CITY OF BOULDER
PARKS AND RECREATION ADVISORY BOARD AGENDA ITEM

MEETING DATE: August 24, 2015

AGENDA TITLE: Civic Area Park Site Plan and Master Plan Discussion Item

East End Development 1&2

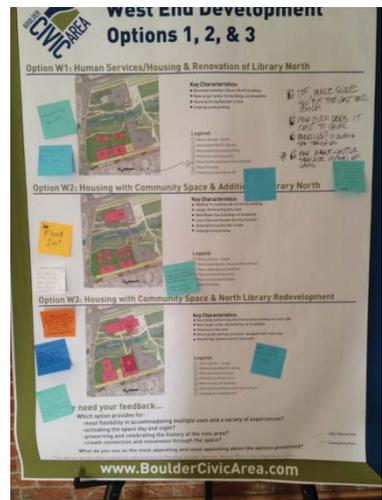
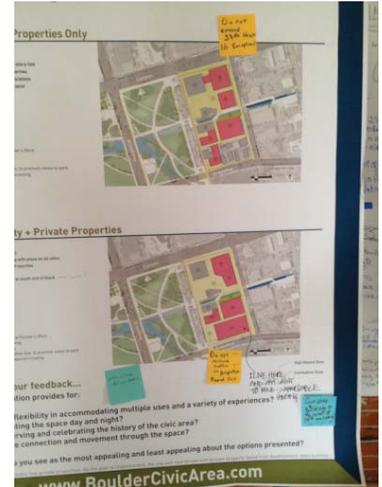
- Do not exceed 38ft height. No exceptions!
- Where will we fill our tubes?
- Do not increase traffic on Arapahoe. Maxed out.
- Gunshop and buildings on the corner of 14th are historic!
 - Over 100 years old!

Creek Promenade – Site Plan

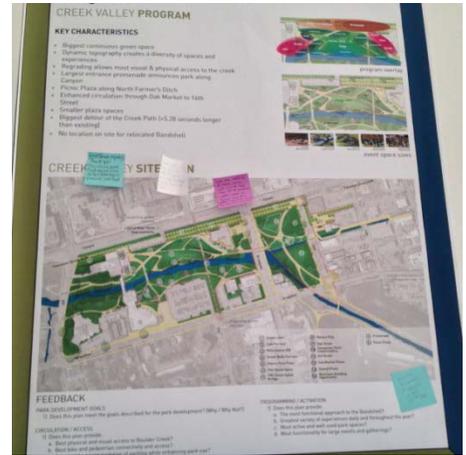
- We need high quality, flexible event space north of the creek (boulder creek fest, Arts fest, Microbrew fest, etc.)
- Keep the Bandshell but of the way preserve mountain views and free circulation
- Remove bandshell
 - Keep bandshell
- It would be great to have the bandshell close to the Farmers Market away from Canyon (less noise)
- Bandshell would be better facing East over by #11 in this plan it blocks BMOCA view into park
- Lots of bike path vs. ped conflicts
- Uninteresting rectangle reflect the creek or downtown or both – add contextual response
- Like the bandshell and okay to relocate but not sure this location cuts noise sufficiently
- This has less impacts on employee parking, yet improves the outdoor experience (bike path is nice distance from the muni bldg. with nice area for trees)
